RIN 0648-XA811

Takes of Marine Mammals Incidental to Specified Activities; Taking Marine Mammals Incidental to an Exploration Drilling Program in the Chukchi Sea, Alaska

ACTION: Notice; issuance of an incidental harassment authorization.

Figure 1. Source levels in 1/3-octave bands for the drillship Discoverer and ice management surrogate vessel (the ice handler Maersk Rover).

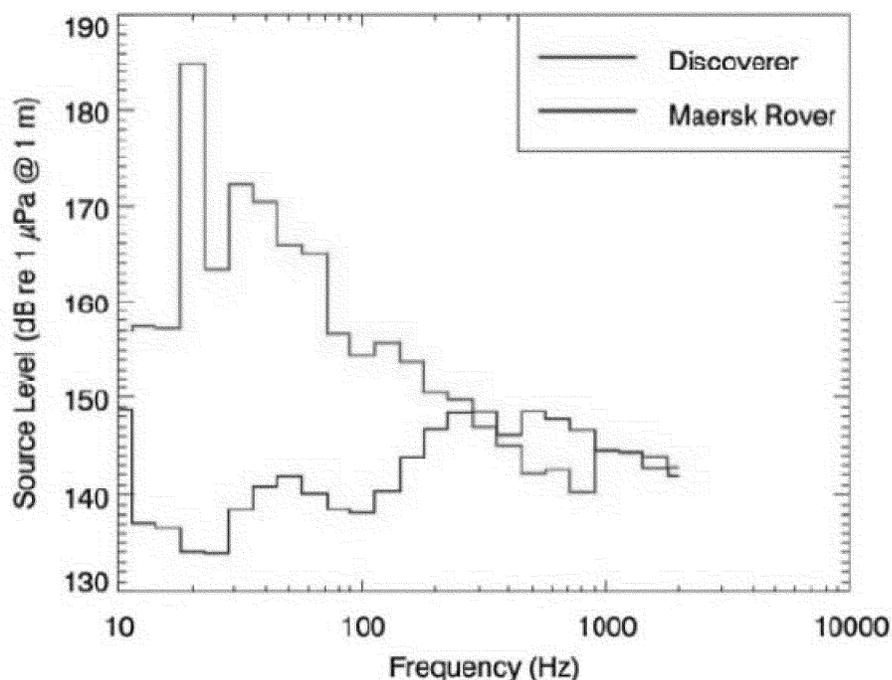
Comment 26: The MMC states that it is not clear which specific source level was used to model the size of the corrected 120-dB re 1 μ Pa harassment zone for the *Discoverer*, as the reported source levels for the *Discoverer* ranged from 177–185 re 1 μ Pa at 1 m. It also is not clear how the source level measurements taken in the South China Sea were incorporated in the model to estimate the 120-dB re 1 μ Pa harassment zone in the Chukchi Sea.

Response: The modeling analysis considered 1/3-octave band levels to account for frequency-dependent propagation effects that cannot

adequately be characterized with broadband analysis. The 1/3-octave band source levels were obtained from dedicated measurements of the *Frontier Discover* (now *Noble Discoverer*) during drilling activities in the South China Sea. A plot showing these levels is provided in the response to *Comment 27*, and the corresponding broadband levels could be computed by summing those if required. The modeling approach applied by JASCO Applied Science was the MONM parabolic equation acoustic propagation model in each 1/3-octave band from 10 Hz to 2 kHz. The resulting received band levels were summed to compute the broadband received levels at many depths, distances and directions from the planned drillship location. Representative sound level threshold radii were determined by calculating the 95th percentile distance, over all azimuths, at which the maximum threshold over all depths was received. This approach considers that animals may sample multiple depths as they pass by the drilling operation.

Figure 2. Temperature, salinity, and sound speed profiles at the Burger prospect obtained from the GDEM database for October.

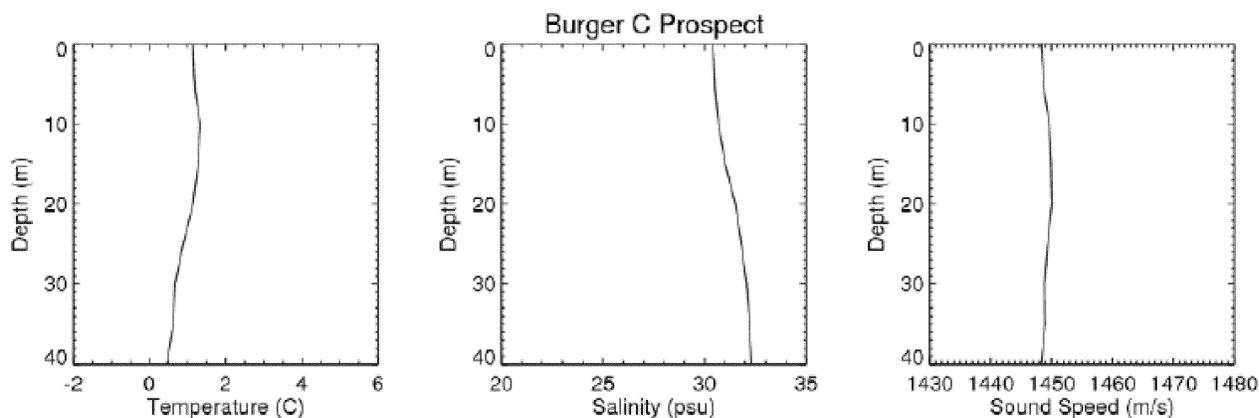
Comment 29: Dr. Bain states that the correction factor of 1.5 applied to the distance to the 120 dB contour is inadequate to conservatively account for the variability.

Response: The concern raised here is that the sound speed profile used for acoustic modeling of drill rig noise may not account for changes to the salinity and temperature profile that could influence and create variability in sound propagation, and the resulting variability might lead to conditions in which model estimates would not be conservative. The location-specific sound speed profiles considered for this modeling study were obtained from the GDEM database for conditions in July and October. A modeling study (Johnston *et al.*, 2009) investigated the difference in sound propagation for both months and showed longer-range sound propagation using the October profile. To be precautionary and to avoid underestimating the propagation, the modeling at the Burger prospect that was used for marine mammal effects assessment was conducted using the October profile (see Figure 2). Therefore, a correction factor of 1.5 is appropriate in this circumstance.

Figure 3. Band levels for the Kulluk during drilling.

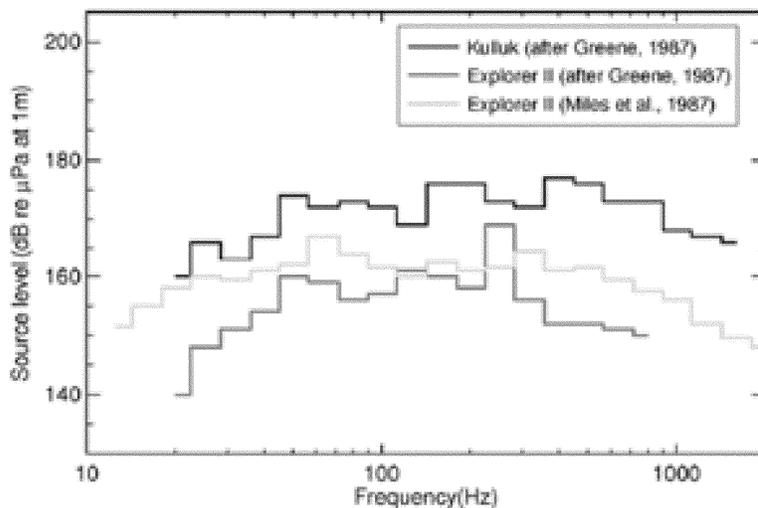
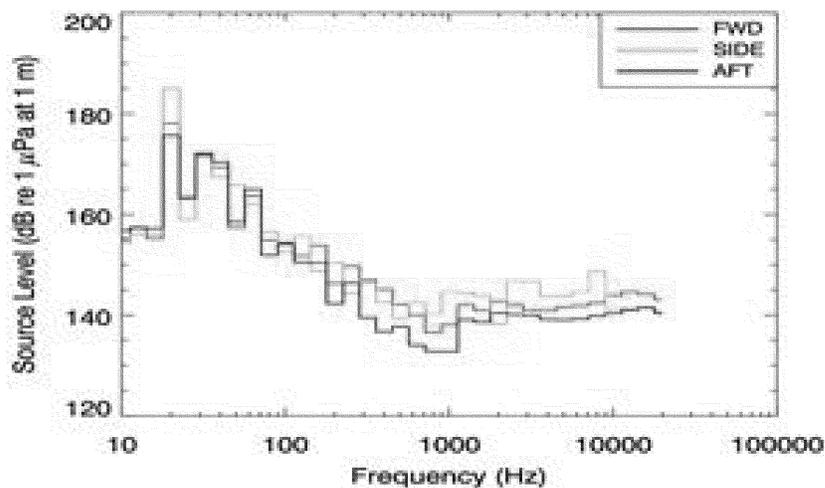
Comment 37: The NSB and AWL note that the modeled 120-dB isopleths for the *Discoverer* are different in the Beaufort and Chukchi Seas (with the isopleth being slightly smaller in the Chukchi Sea). Additionally, they question if the 120-dB isopleth for the *Discoverer* is correct given its nearly identical source level to the *Kulluk* drill rig (proposed for use in the Beaufort Sea), for which sound propagates out to the 120-dB isopleth at a much farther distance. If the modeled propagation is incorrect for the *Discoverer*, then this would bias the take estimates low.

Response: The primary reason for the difference in the distance of the 120-dB isopleths for the *Discoverer* in the Beaufort Sea vs. the Chukchi Sea is due to differences in the geoacoustic parameters for the two seas that were input to the model. Water depth, seabed density, and seabed sound speed are generally the most important parameters that influence sound propagation.

Differences in sound propagation from the two rigs are real and are caused by differences in the design of the two vessels. While the broadband source levels for the *Discoverer* and *Kulluk* may be similar, their spectral properties differ considerably. Acoustic modeling considers the source levels in 1/3-octave frequency bands. Figures 3 and 4 show the band levels for both drillships during drilling. Of key importance are the significantly lower levels of the *Discoverer* in the 50 to 500 Hz bands that propagate well in the relatively shallow waters of these drilling operations. While the *Discoverer* apparently has higher band levels below 50 Hz, this energy is more rapidly attenuated than higher frequency sound energy. This characteristic of sound propagation in shallow waters leads to predominantly mid-frequency sounds (50–500 Hz) dominating the acoustic field at distance from the drillships. A further consideration is that the *Kulluk* source levels are known to include contributions from support vessels, and much of the mid-high frequency band
